**RESIDENTIAL DEVELOPMENT
MANOR FARM & COPSEYS NURSERY
DENVILLES
HAVANT
HAMPSHIRE**

SUDS INSPECTION REPORT

BARRATT DAVID WILSON HOMES SOUTHAMPTON

25TH FEBRURAY 2016

Image No.6 – Permeable paving with moss in joints

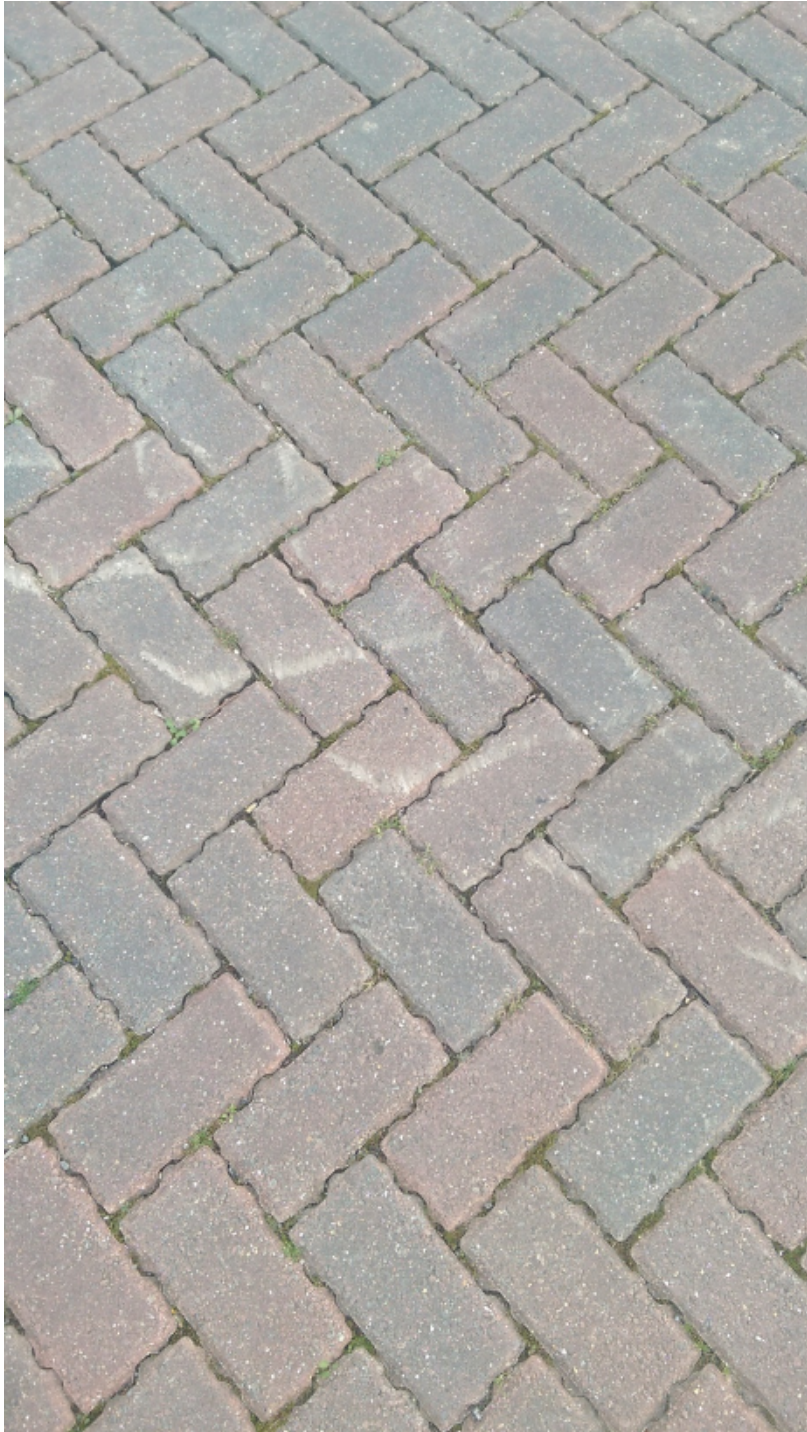
Maintenance of the permeable paving is required ie removal of detritus from the block joints by vacuum sweeping. This will improve performance and longevity of the system
